10/814,136

Tsuyoshi Kaneko

Office Action Summary

Fig. 4

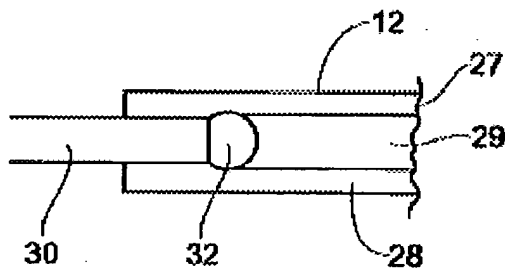
As to claim 1, Henneman discloses a connection structure between optical fibers, comprising: a substrate a plurality of optical fibers, 30 and 29, each having end surfaces; a base member [portion below 32] provided over the substrate [col. 2, lines 10-55]; and a connecting part, 32, provided on a top surface of the base member and joined to each end surface of the plurality of optical fibers [col. 12, lines 3-68].
